Report: TAB Report
Function: Test, Adjust, & Balance
Date: 11/26/2025
Completed By: National TAB

PROJECT
12-08-25 QT #1439 MESA, AZ

Table Of Contents

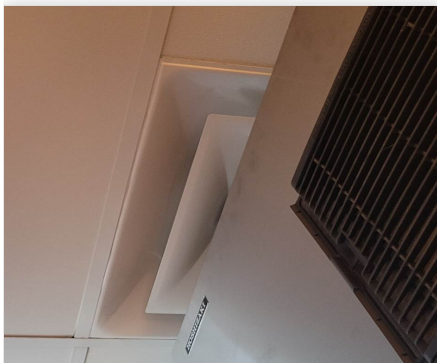
Issue Name : DAMPERS INACCESSIBLE
Description : RTU3 dampers should be accessible for TAB to done properly. Tiles cannot be move due to proximity of light canisters to steel beams and the hood. They are installed too far in to be reached on either side of row of lights. Recommend not installing tiles until kitchen has been balanced.
Created By : National TAB **Assigned To :** National TAB - Dan Hertenstein
Status : Open
Priority : High **Asset Tag :** RT-3
Originated Date : 12/10/2025 - Christine Weale - National TAB

Asset: EF2

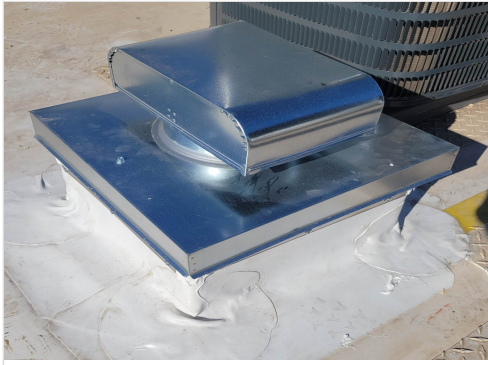
Notes:
EXHAUST FAN IN CEILING, INACCESSIBLE DUE TO COMBI-OVEN, REQUESTED INFO NOT GIVEN.
